**Bid Bulletin #03**

PROJECT: Baldwin Filters Distribution Facility (Bid Package #04)  
Kearney, NE

## ADDENDUM

**PROJECT:** Baldwin Filters  
Main Distribution Center  
Final Construction Package - Big Box  
Kearney, Nebraska

## ADS HP STORM 12”–60” PIPE SPECIFICATION

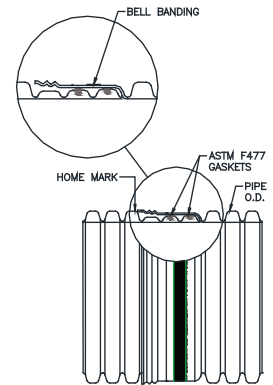
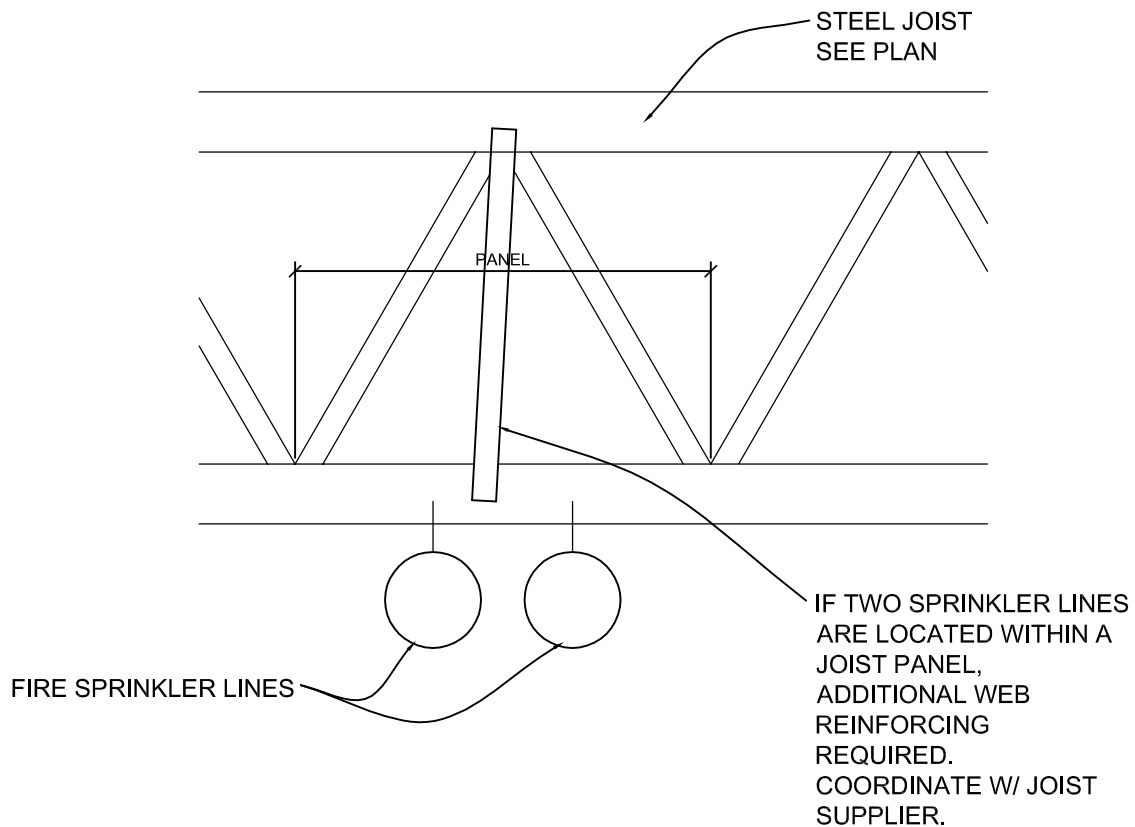
In reference to Section 221413 – Facility Storm Drainage Piping, for storm drainage piping 15” and larger inside the building footprint and to a point five feet outside the building, piping shall be ADS “HP Storm.” Refer to attached information and specifications.

In reference to **Sheet P-101A and P-101B**, all below slab/grade storm drain piping within the building footprint and to a point five feet outside the building footprint that is 15" or larger in size shall be ADS "HP Storm" piping. Refer to attached information and specifications.

## 25 Fire Lines & Joist Detail

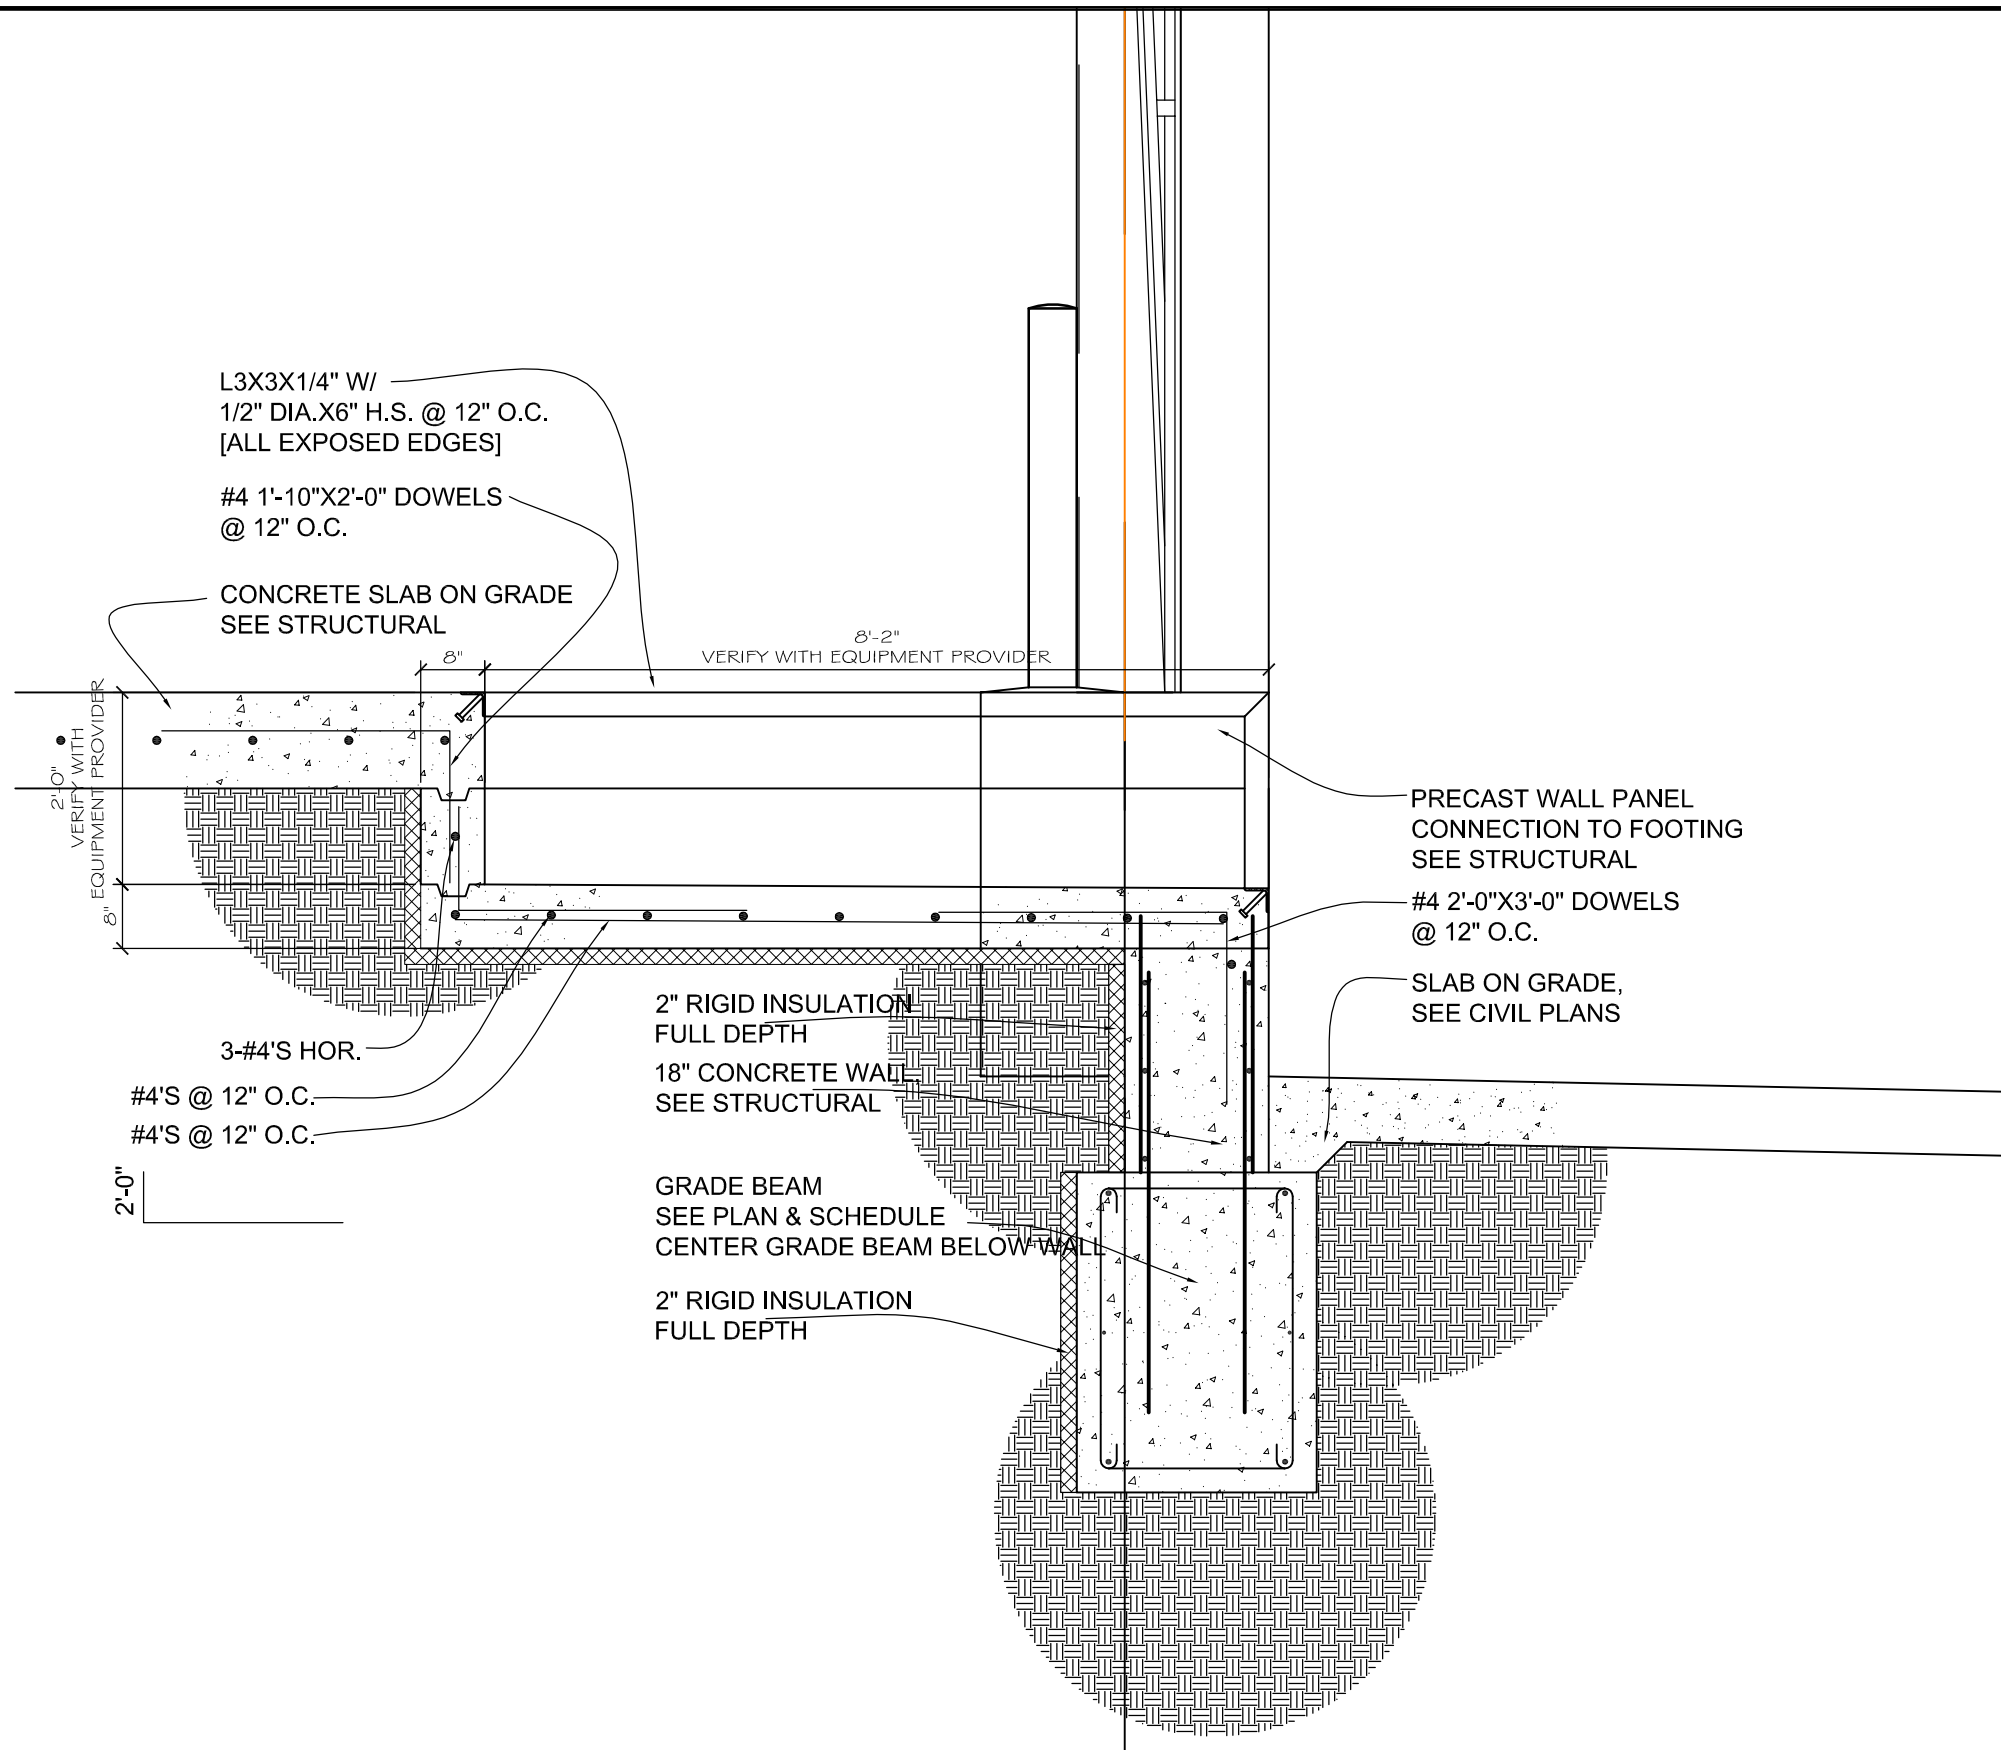
In reference to **Sheet S-504**, see attached detail 25/S-504 pertaining to the support of the fire sprinkler lines and design of the steel joists.

THE CONTRACTOR SHALL COORDINATE THE LOCATION, SIZE, & WEIGHT OF THE FIRE SPRINKLER LINES W/ THE JOIST SUPPLIER.
